# ◀ HEALTH & SAFETY ALERT ▶

## Genie Safety Notice - Level Sensors recall

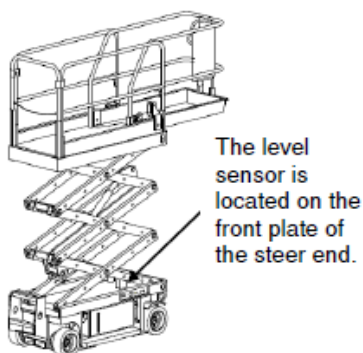
Genie has become aware that customers, who purchased replacement level sensors for the GS, GR, GRC and QS models, may have received the incorrect level sensor from their European service parts distribution centre.

Using the incorrect level sensor, may cause the tilt alarm to sound at a greater slope rating than what the machine is rated for, resulting in loss of machine stability. Machines affected by this safety notice must be removed from service until the following actions are completed:

1. Locate all machines where the level sensors purchased were installed.
2. Inspect the level sensor. The correct level sensor must have a red band around the top. If the level sensor has a red band, continue on to step 6. If the level sensor is other than what is described above, the machine must remain out of service.
3. Order Genie P/N 105142.
4. Replace and test the new level sensor (P/N 823515).

### GR, GRC and QS models:

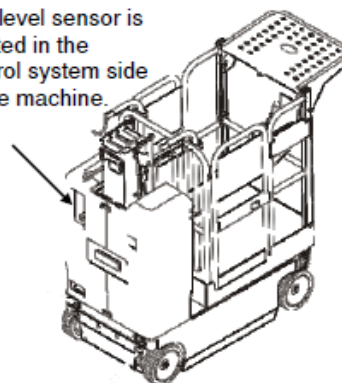
The level sensor is located in the control system side of the machine.
